Access Compliance Report Public Rights-of-Way (Curb Ramps)

Main Street: **FORUM_WAY** Cross Street: **TRIUMPHAL_WAY** Location: **NW**

ADA ID: **RPAT211015142325** Ramp Type: **Type 1 - Perpendicular Diagonal** Initial Pass/Fail: **Pass** Overall Compliance: **No** Severity Score: **25**

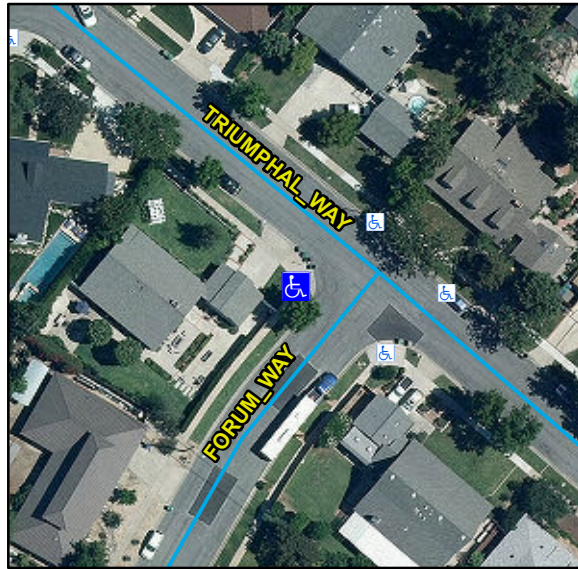
R304.2.2, R204.3, R304.2.1, R304.2.2-Perp, R304.3.2-Para, R304.5.3, R305, R304.5.4, STD 1115

Remove & Replace Curb Ramp With Two New Directional Ramps or Equivalent. Remove & Replace Gutter.
